1617 S MERIDIAN
 PUYALLUP, WA 98371

STORMWATER PLAN

STORMWATER DETENTION AND CONTROL VAULTS

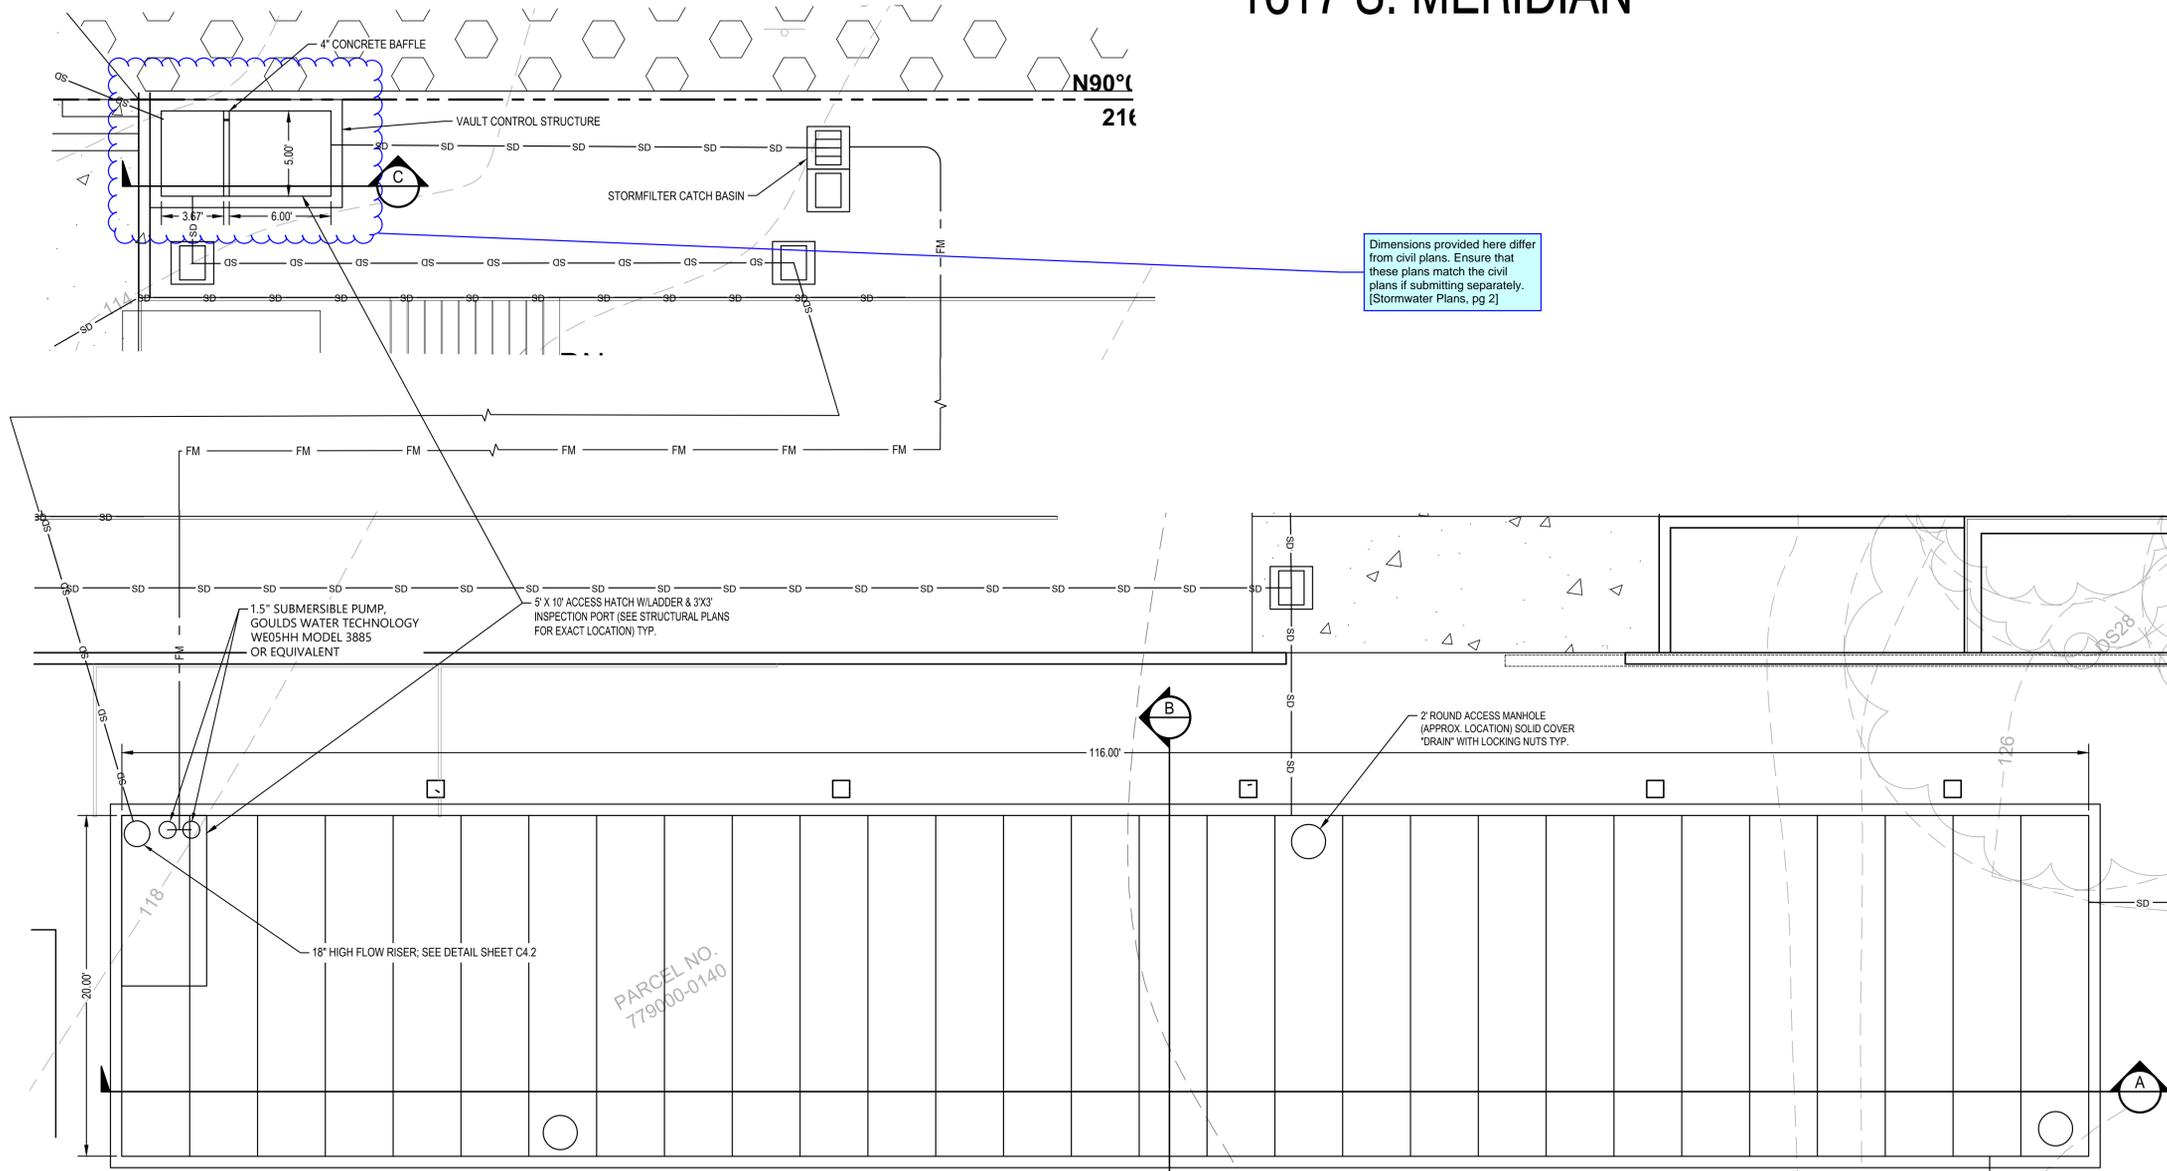
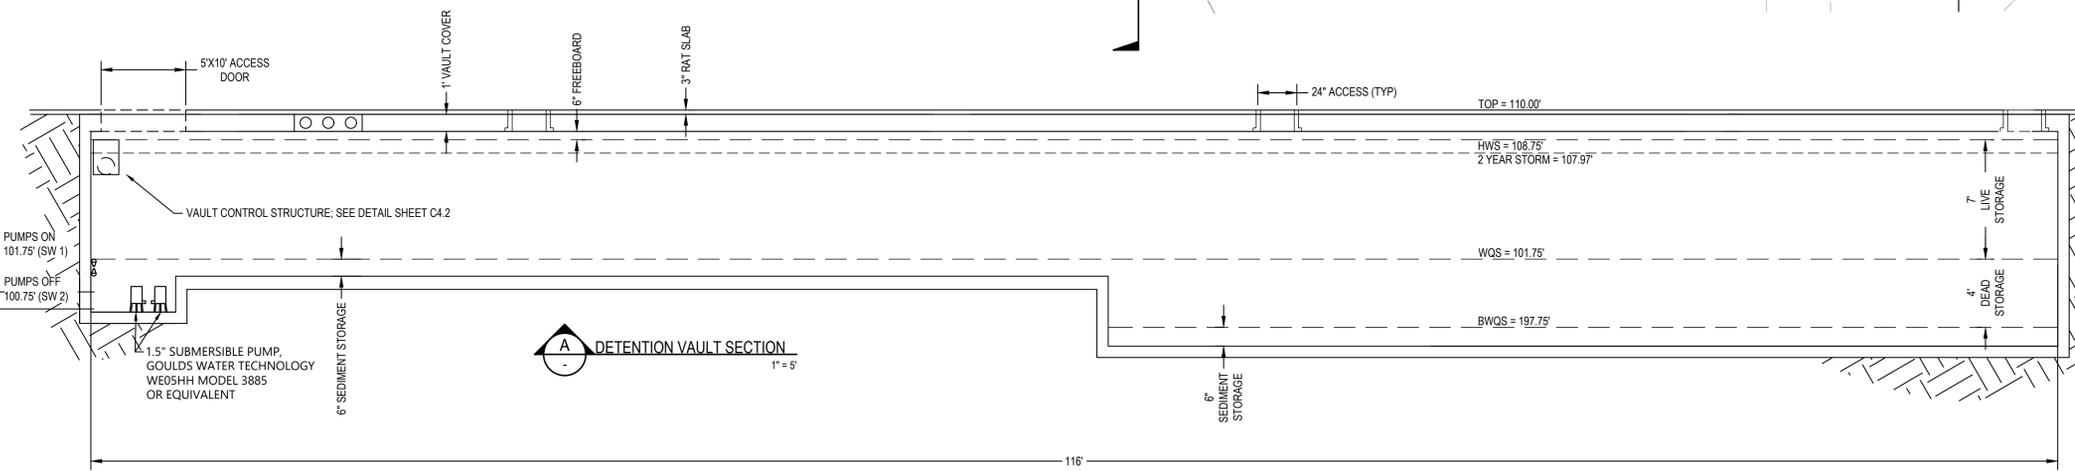
Dimensions provided here differ from civil plans. Ensure that these plans match the civil plans if submitting separately. [Stormwater Plans, pg 2]
